PGandE Letter No.: DCL-84-219

LICENSE CONDITION 2.C.(11)

FINAL REPORT

SECTION 7

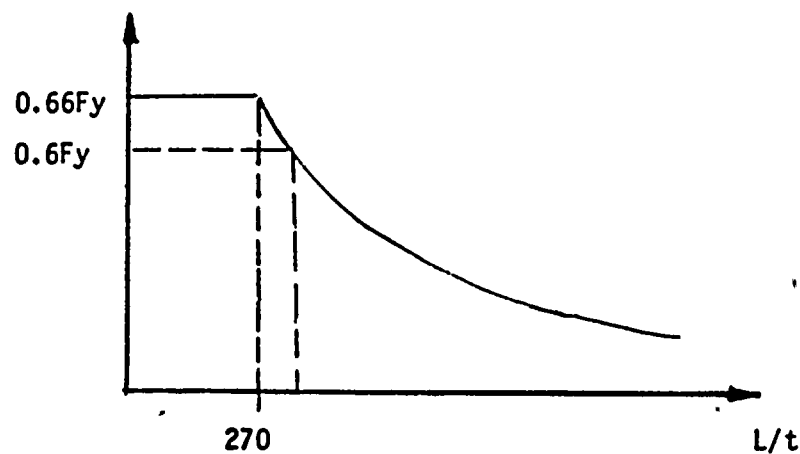
Our understanding of the Staff's concern involves the AISC's position on the Australian data and the appropriateness of its application. To address this, two pieces of additional information are provided as Attachments 7(b)-3 and 7(b)-4. PGandE believes that the AISC's positive and supportive position has been reflected in these two attachments.

The staff has expressed a concern about using the L/t limits given in the Australian paper if the allowable bending stress is reduced from $0.66 F_y$ to $0.60 F_y$. The sketch below shows that as the allowable bending stress is reduced the L/t limit increases. It should be noted that the theory developed in Attachment 7(b)-4 recommends a L/t limit of 300.

There are additional reasons why the L/t limit of 270 is conservative as explained below:

- o The L/t limit of 270 (or 300) is derived from the bending about the major principal axis. This is the loading case in which the angle is most vulnerable to buckling and is generally not the direction of loading in pipe support applications. In pipe support design, the main loading is generally applied in the direction parallel to one of the angle legs. For such cases, the L/t limit may be as high as 990 and 690 for a B/t ratio equal to 6 and 16, respectively where B is the length of leg. However, the L/t limit of 270 is applied to all angle bending load cases in this project. This allows an additional implied conservatism.
- o All of the L/t limits derived in the Australian papers and used in the Australian testing are for uniform bending moment along the entire beam. Again, this is the most critical lateral buckling condition and generally does not exist in pipe support application.

Based on the foregoing, it is concluded that the AISC supports and recommends use of the Australian paper. Project design criteria meet or exceed the requirements set forth in the Australian paper and the AISC. Therefore, PGandE believes the Project criteria on bending for angle sections are satisfactory and acceptable.

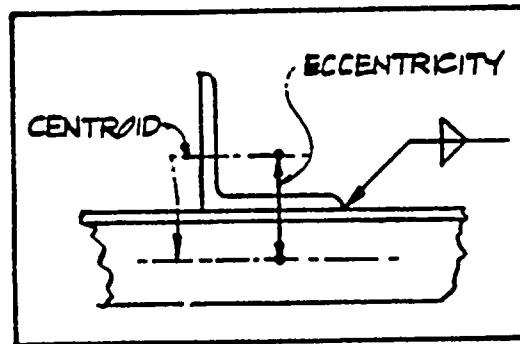
As a result of the discussions during the NRC Staff and PGandE meeting on May 9, 1984, a better understanding of the Staff's concern for lateral/torsional buckling was obtained. This issue concerns failure of structural angles in local plate buckling rather than the lateral and torsional buckling discussed in the Winter et.al.⁽¹⁾ paper.

A review of the test results included in a paper by Kennedy and Murty⁽²⁾ indicates that structural angles can fail in local plate buckling when the b/t ratio is in excess of 15. The theoretical results in this paper indicate that the buckling load is less than 5% below the yield stress for standard structural angles with a $b/t \leq 12$. In order to explicitly address the NRC Staff's concern regarding local buckling of angles, the design drawings will be reviewed during the present effort and occurrences where $b/t > 12$ will be documented. For angle sizes used on the Diablo Canyon Project, the b/t ratio is usually 9 or less. It should be noted that this screening criterion is more stringent than the AISC criterion of $76/\sqrt{f_y}$.
